SUBJECT: Withdraw of the November 16, 2015 Application for Modification, AND Application for Modification with Additional Information for Section 404 Individual Permit and Section 401 Individual Water Quality Certification for the US-74 Monroe Connector/Bypass in Union and Mecklenburg Counties. STIP R-3329 and STIP R-2559, Division 10, Debit WBS Element 34533.1.TA1 in the amount of \$570.

Reference: US Army Corps of Engineers (USACE) 404 Permit issued May 8, 2015; Action ID: SAW-2009-00876
NC Division of Water Resources (NCDWR) 401 Water Quality Certification Permit issued March 6, 2015; NCDWR Project No. 02-0672 V3

The North Carolina Department of Transportation (NCDOT) is in the process of constructing the Monroe Connector/Bypass, as authorized by the USACE and NCDWR as referenced above. NCDOT is requesting a permit modification for ten Permit Sites: 3, 5, 29, 30, 37, 46, 47, 48, 54, and 57, which are detailed below. Two other sites, 6 and 60, have revisions in jurisdictional areas that do not require a permit modification (see below).

Permit Site 29 (Revised Permit Drawings 118 and 119 of 267):

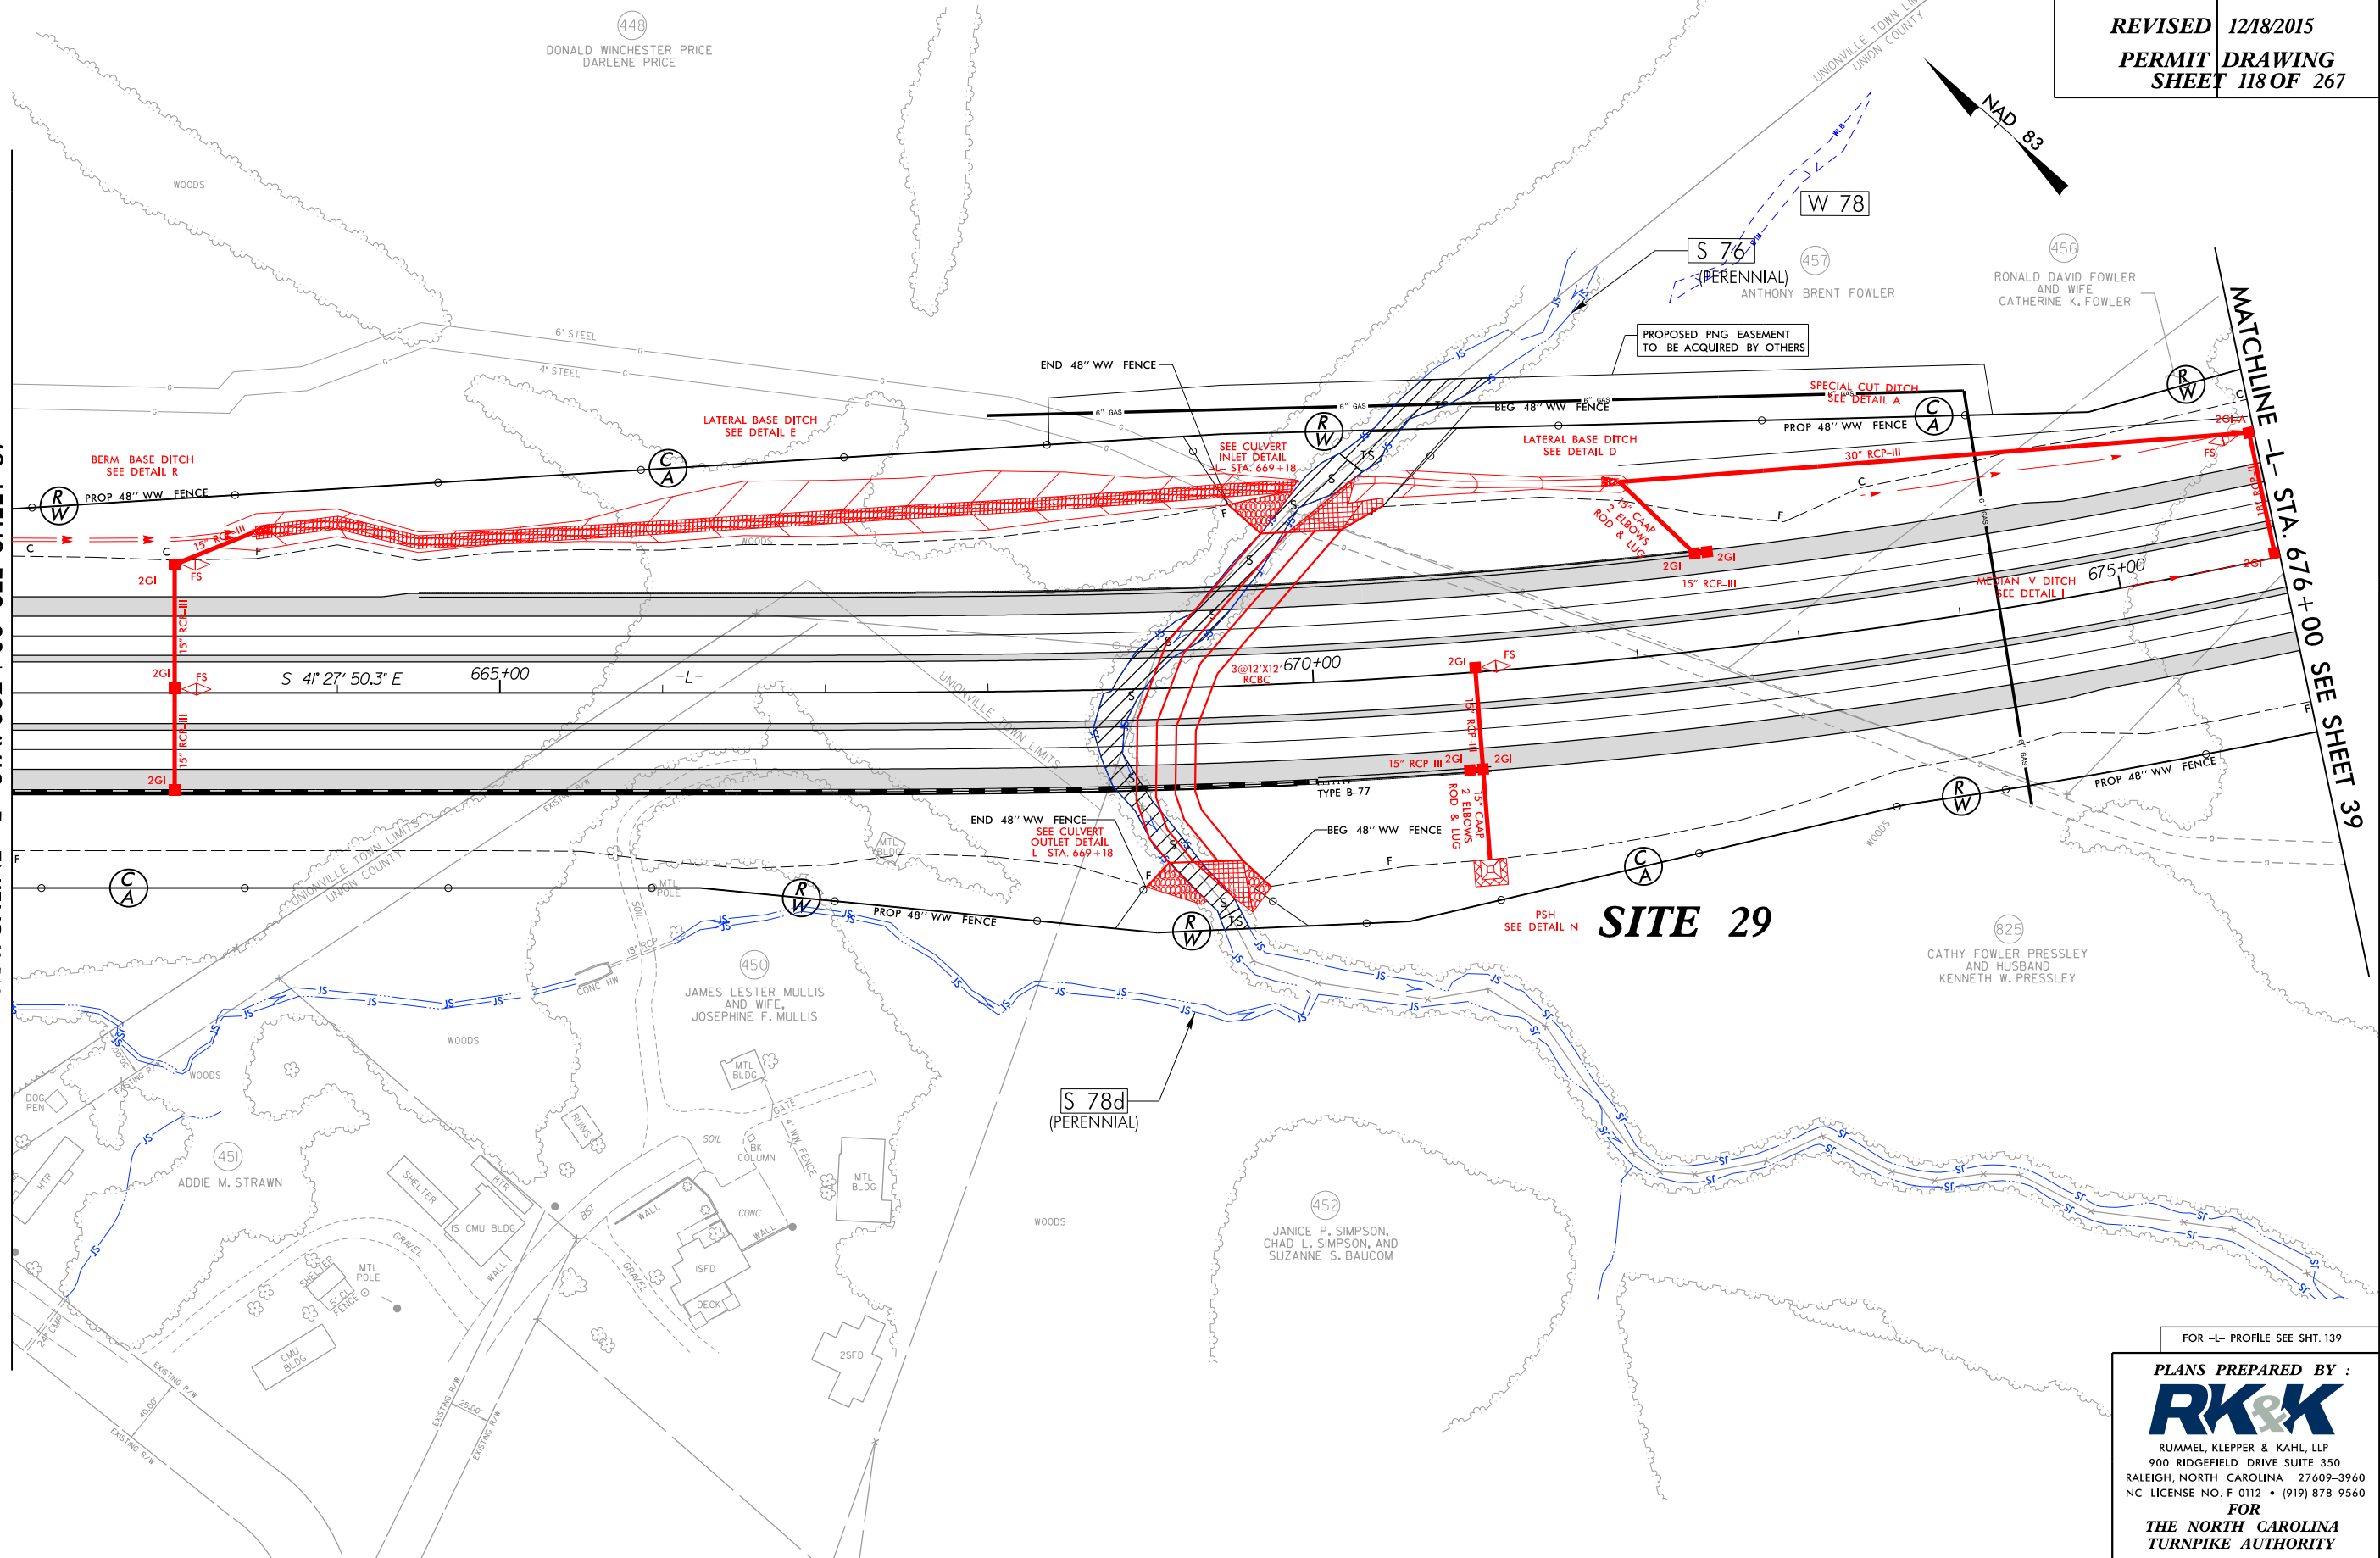
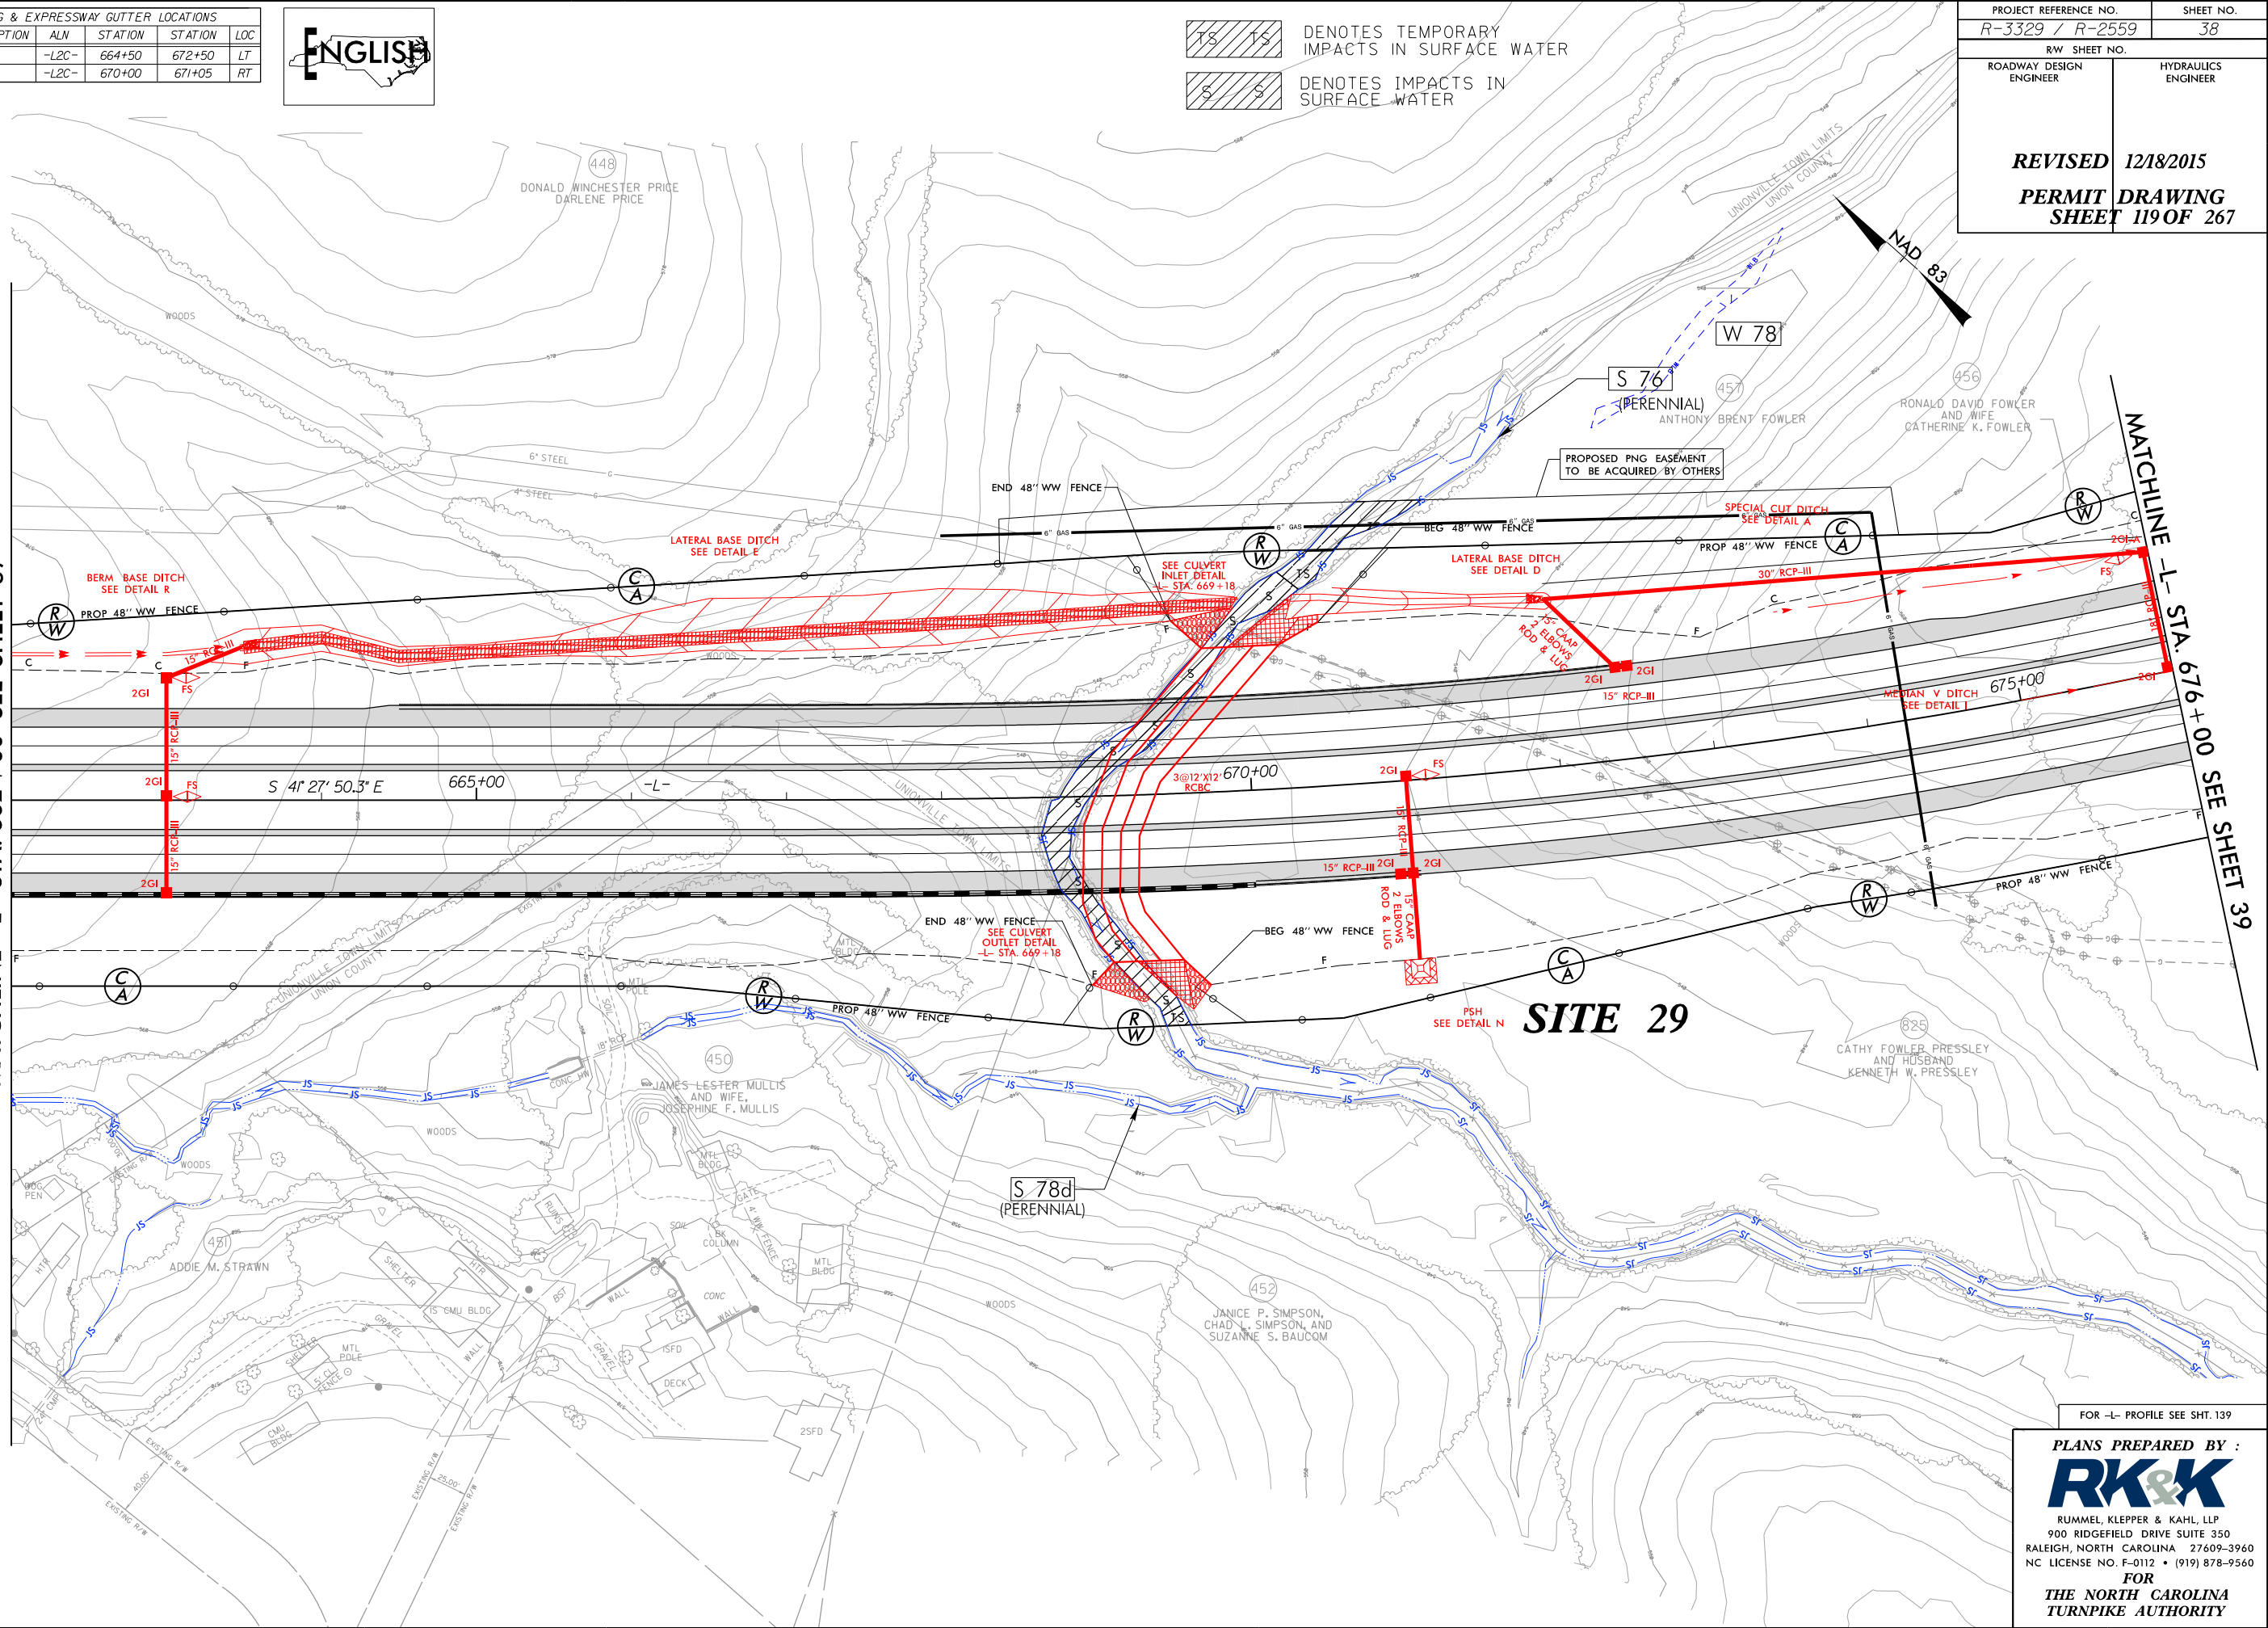
In addition to the previously permitted 241 lf of permanent stream impacts, 123 lf of bank stabilization, and 38 lf of temporary stream impacts, **a gas line relocation will result in 0.02 acre and 55 lf of temporary impacts to S076 (East Fork Stewarts Creek).**
